Township of Gloucester
Zoning Board of Adjustment
Wednesday, October 25, 2017
7:00 P.M.

Agenda

TOWNSHIP OF GLOUCESTER
Inter-office Correspondence

RE: **APPLICATION #172051C**
Robert Speese
405 Station Avenue
BLOCK 801, LOT 23

RIGHT SIDE ELEVATION

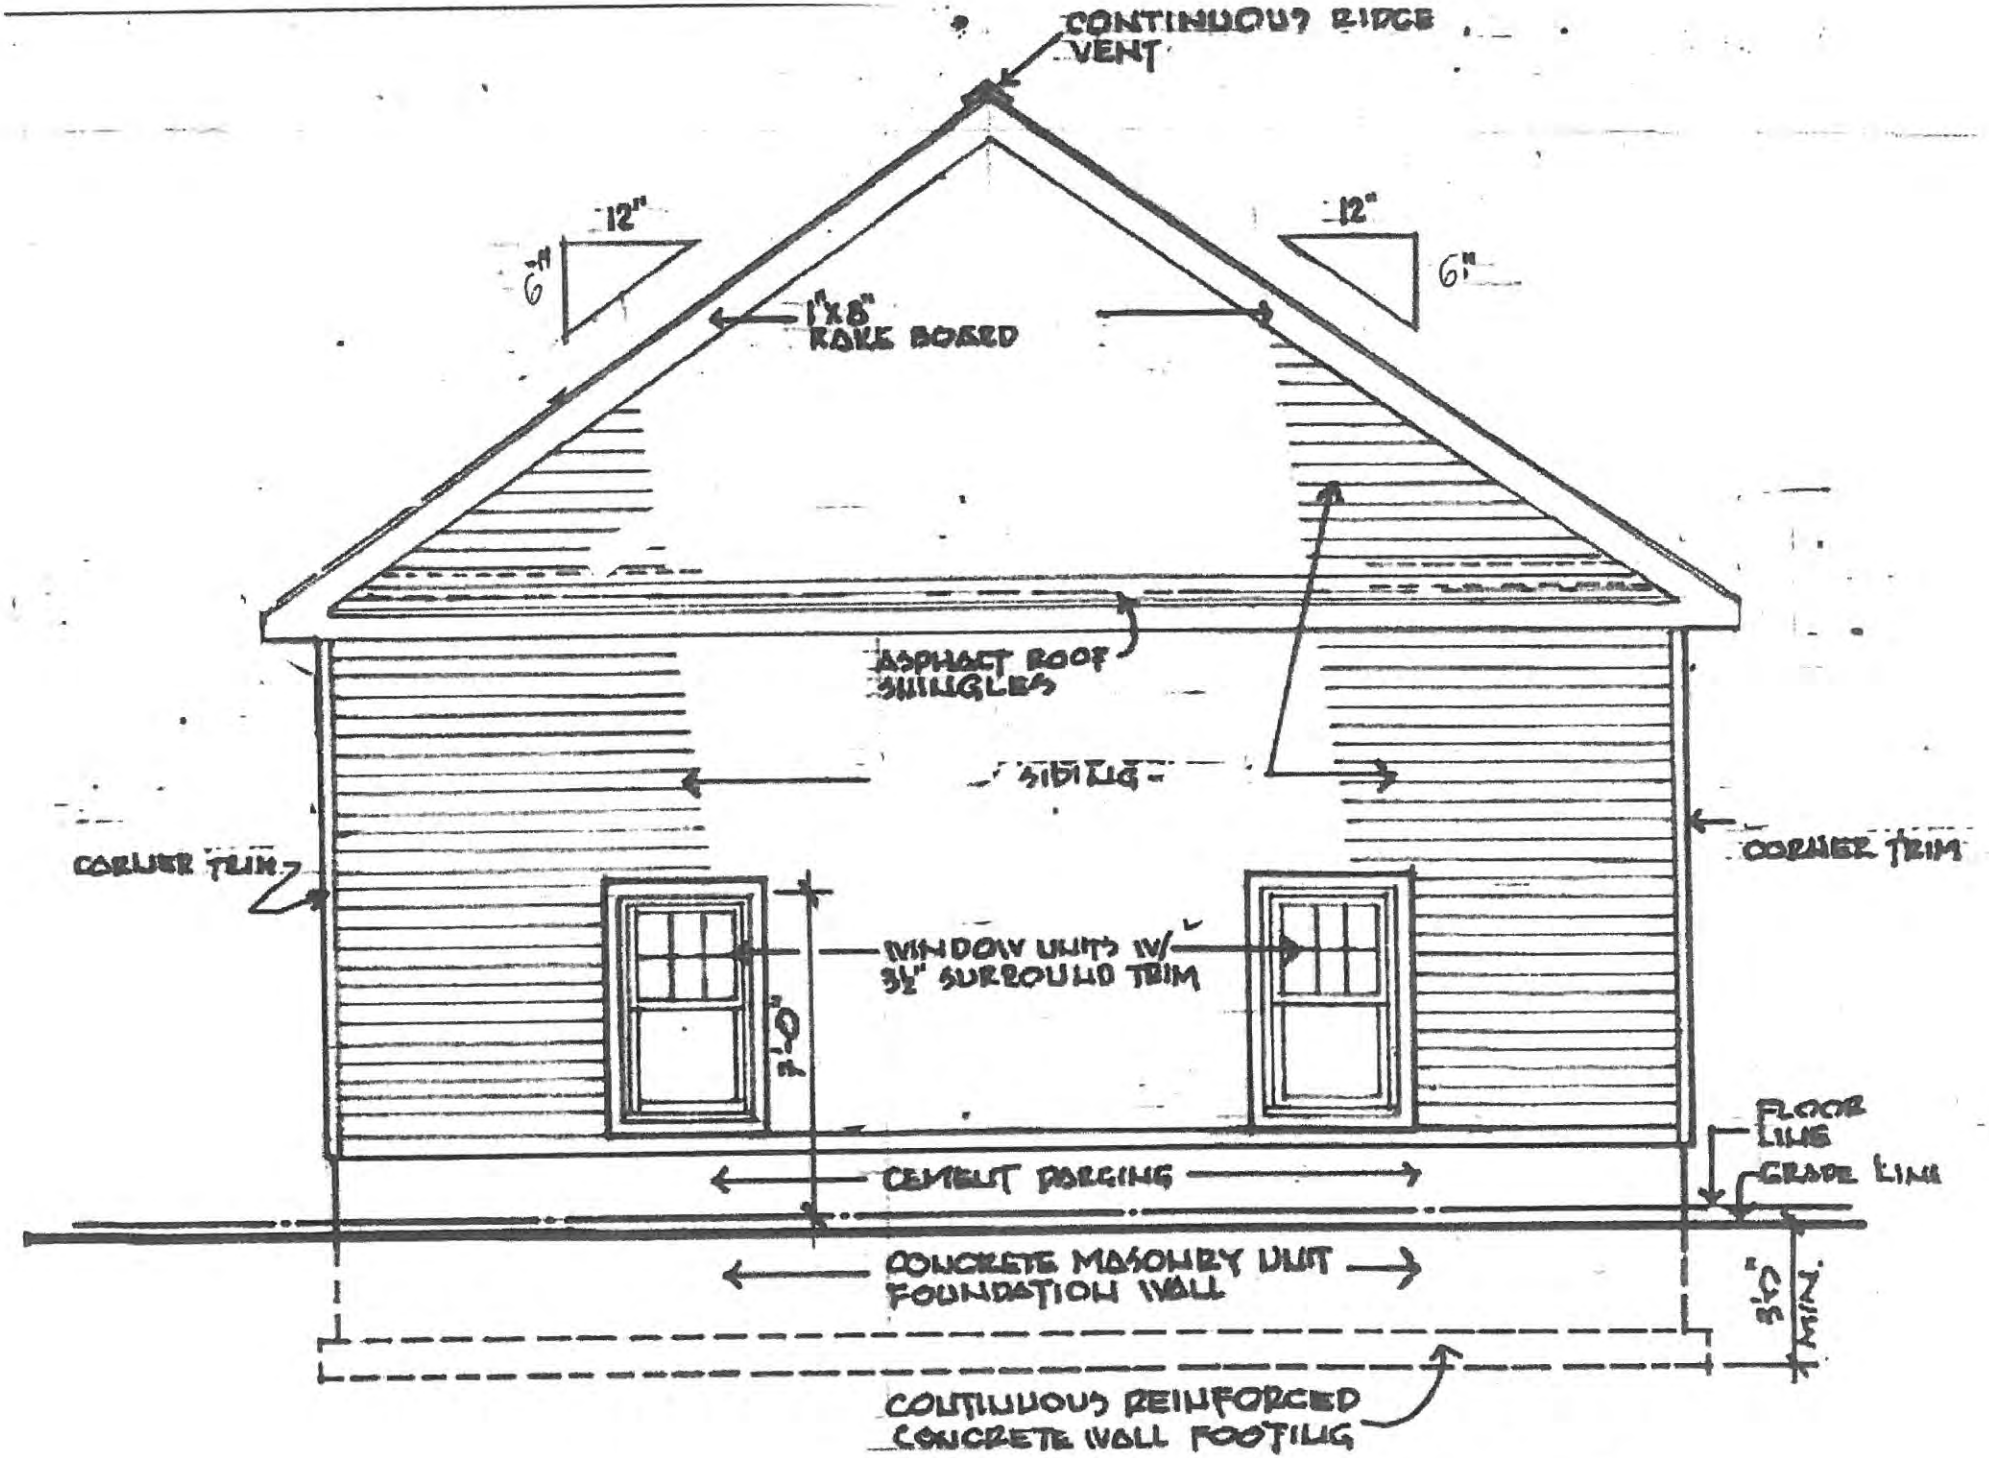
1. Area: (1,200 sf. provided v. 800 sf maximum allowed).
2. Side wall height: (14 ft. provided v. 9 ft. maximum allowed).
3. Garage Height: (20 ft. provided v. 14 ft. maximum allowed).

OUR RECORDS ALREADY SHOW ONE "SHED" ON PROPERTY. THIS GARAGE IS EXTREMELY LARGE FOR RESIDENTIAL AREA - HEIGHT of 22' IS WAY TOO HIGH FOR RES. AREA. COULD BE DETRIMENT TO NEIGHBORS. NEED TO CLARIFY FOR RES USE ONLY AND NO COMMERCIAL USE.
